**OHIO TURNPIKE AND
INFRASTRUCTURE COMMISSION**

ADDENDUM NO. 1

SERVICE PLAZA RENOVATIONS

**CHANGES TO PLAN DRAWINGS
Sheet Number 6-A4.0, 6-A7.6, 6-8.1, 7-AS1.0 and 7-A8.1**

7-AS1.0

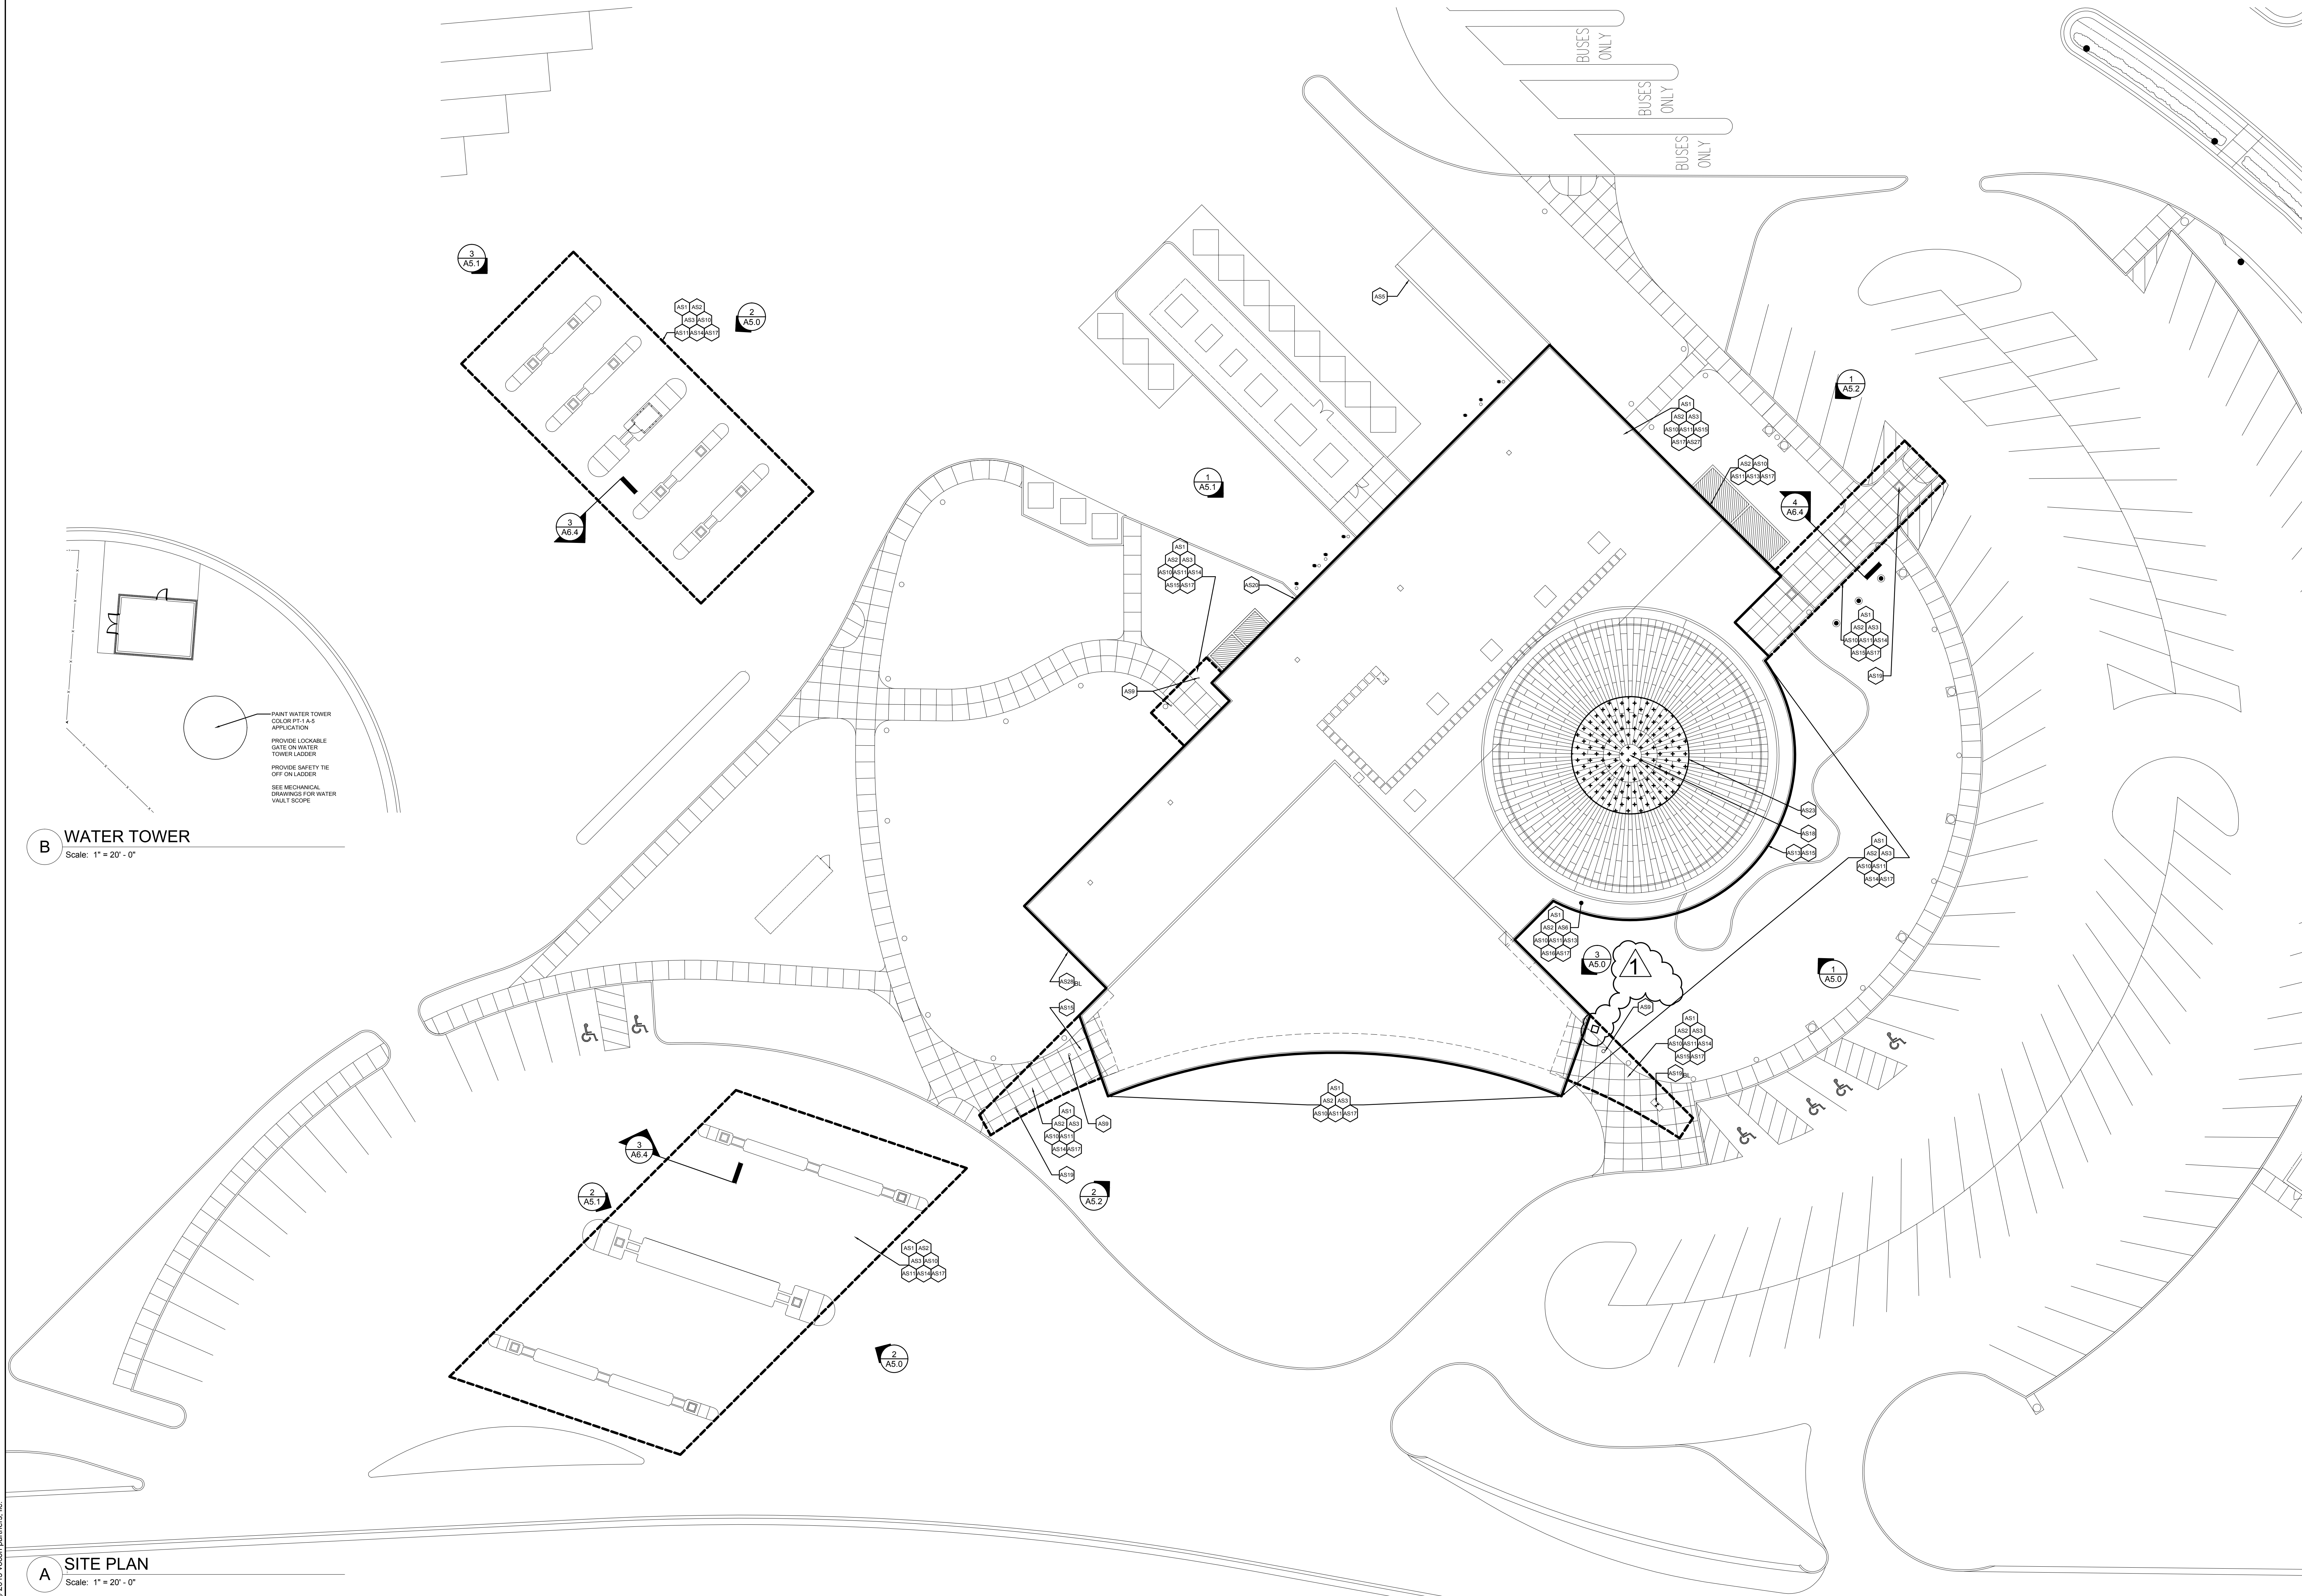
Q#9 On drawing 7-AS1.0, Note AS22 states: replace existing mail box with new. Please verify manufacturer and model of new mail box.

A#9 Replacement of the existing mailbox with new is hereby removed from the scope of the project. This affects 7-AS1.0 Plan Sheet.

7-A8.1

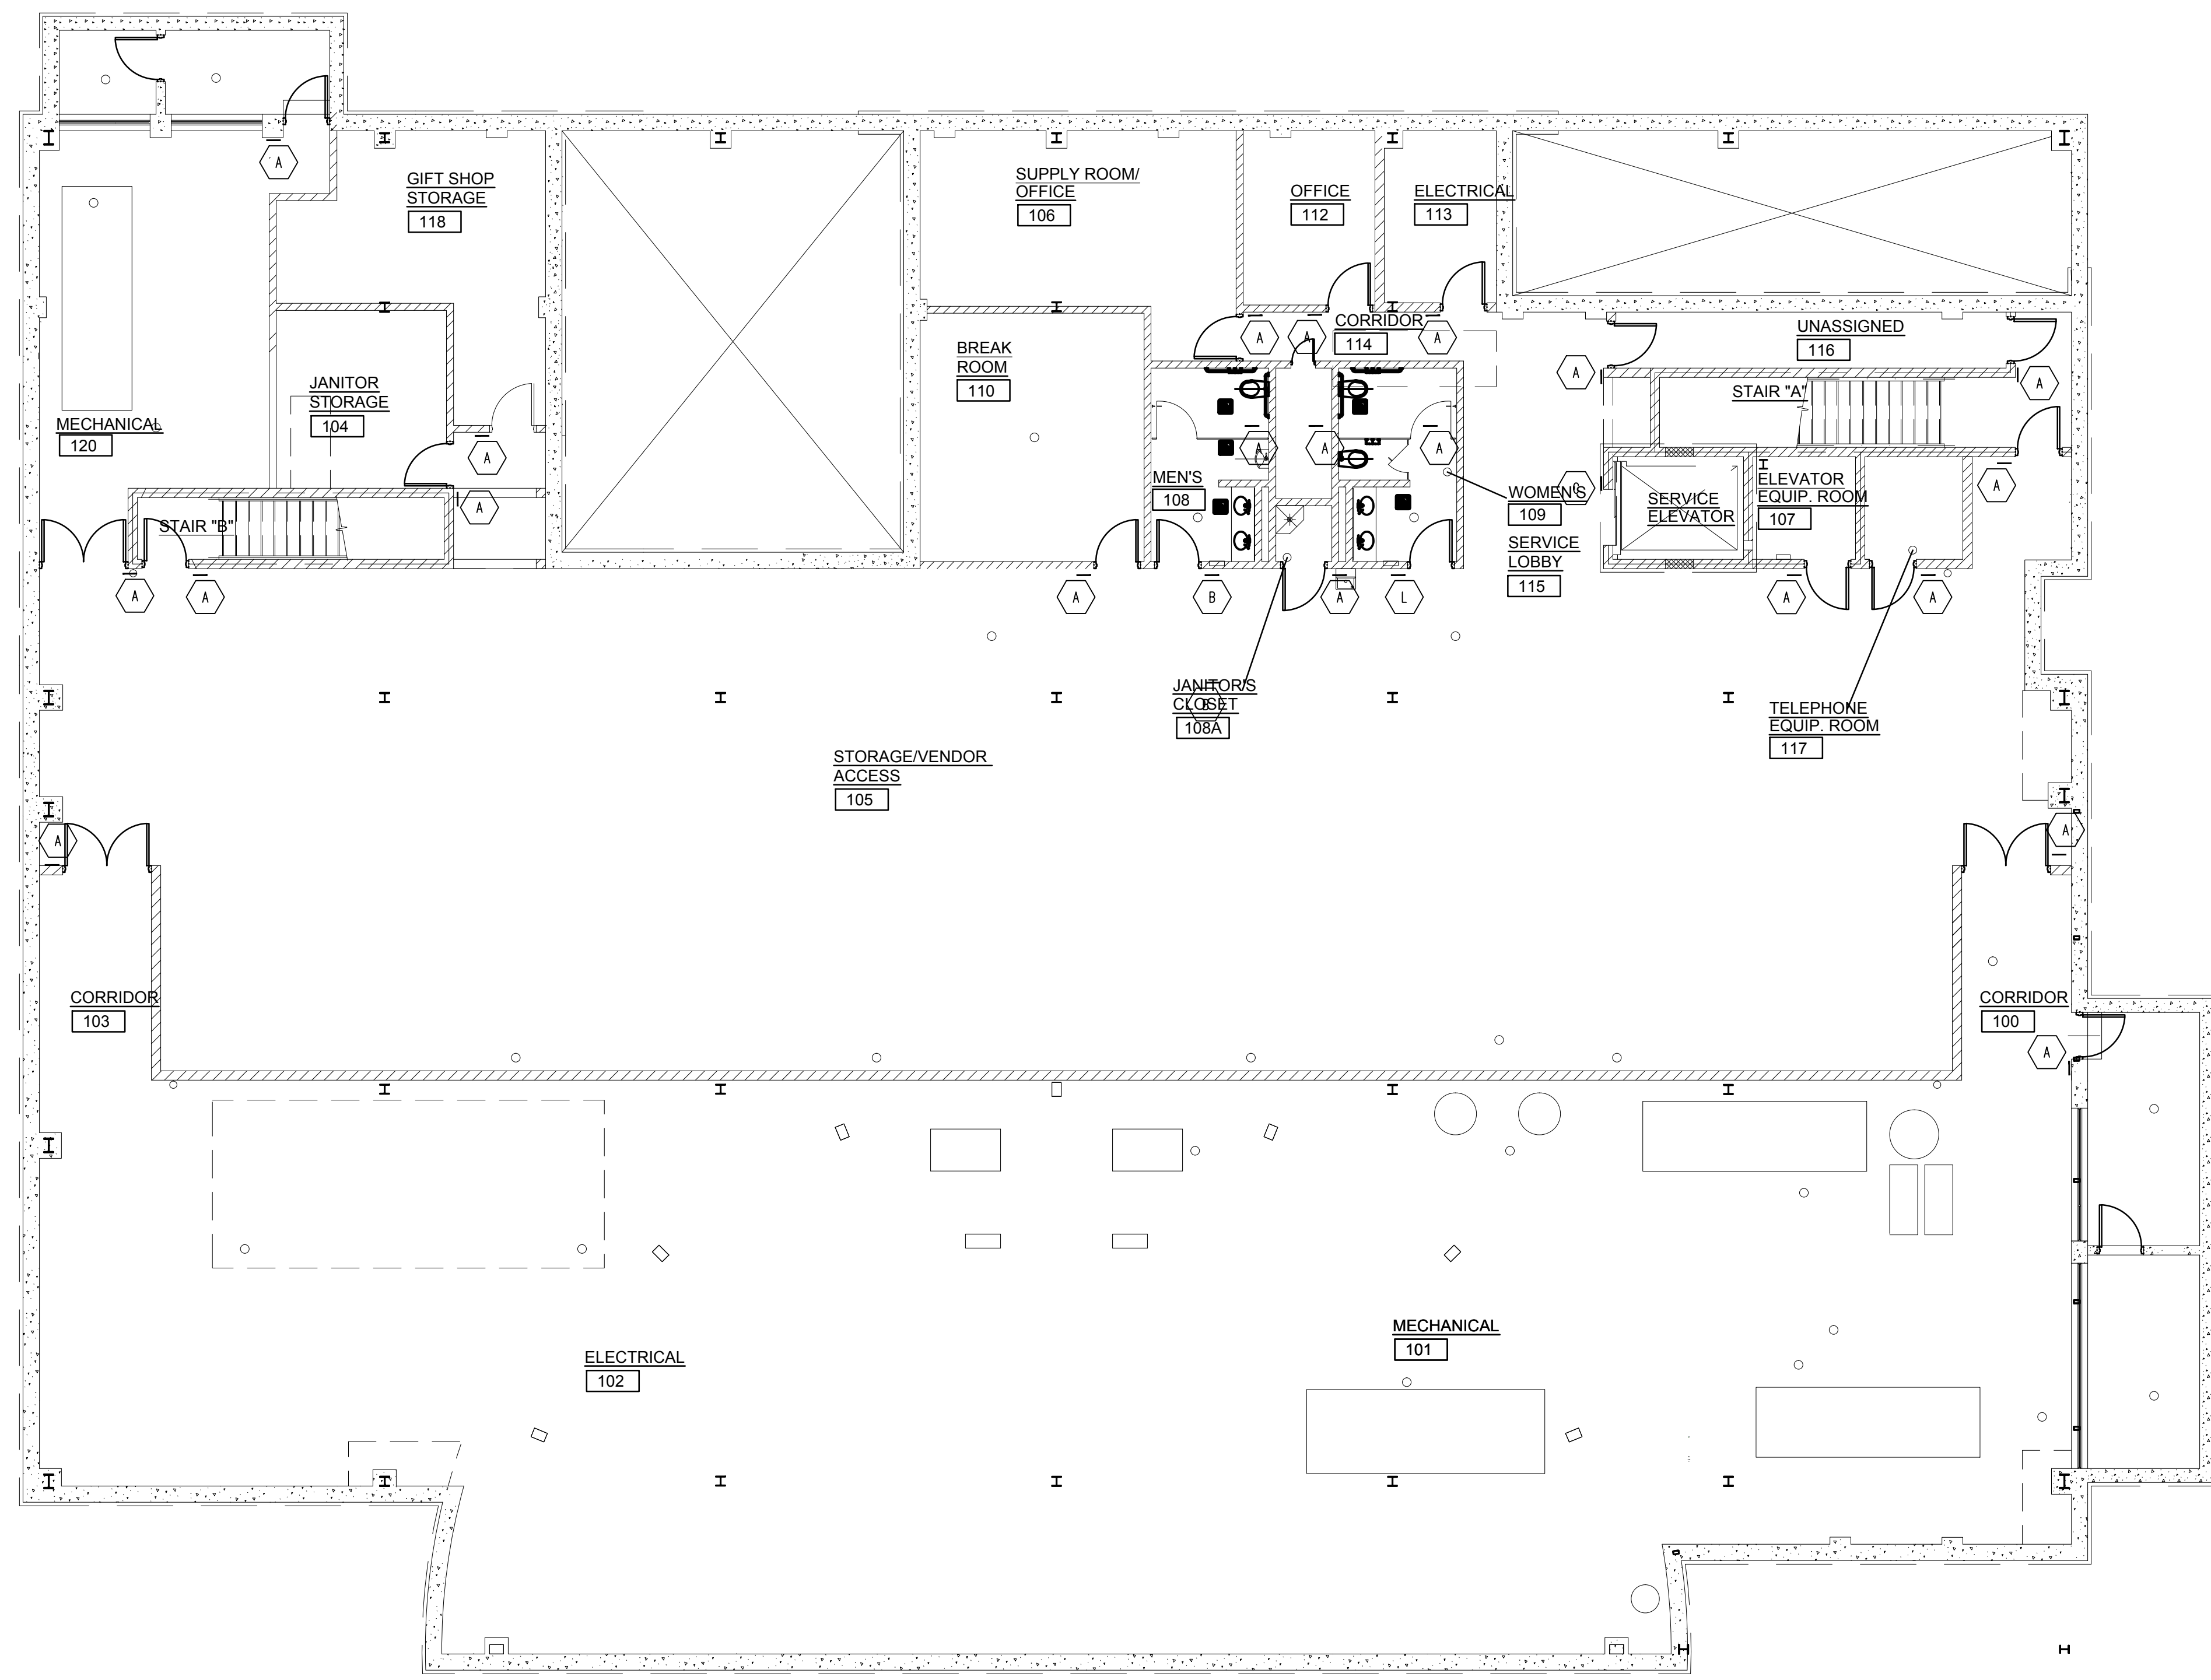
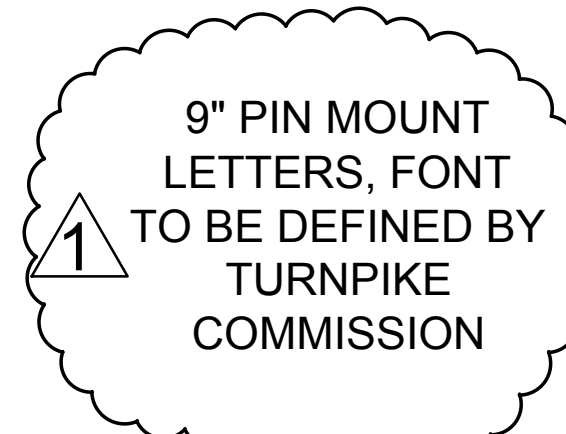
Q#7 Regarding Dimensional Letters: On the Signage Plan, for "Sign Type N", 12" height is stated; but in the "General Notes", 9" is specified. Please clarify the desired height for the dimensional letters.

A#7 Sign Type N letters are to be 9-inches in height. This clarification affects 6-A8.1 and 7-A8.1 Plan Sheets.

TYPESTYLE OF SIGN TYPE "N" LETTERS TO BE HUMANIST 521BT - FINAL LAYOUT AND TYPESET TO BE APPROVED BY ARCHITECT PRIOR TO INSTALLATION. COLOR TO MATCH SHERWIN WILLIAMS SW655 MAJESTIC PURPLE. SEE DWG. ASS1 AND ARCH DWGS. FOR LOCATIONS OF SIGN TYPE "N". CAPITOL LETTERS TO BE 9" IN HEIGHT AND ALL LETTERS TO BE 3/8" THICK, TYP.
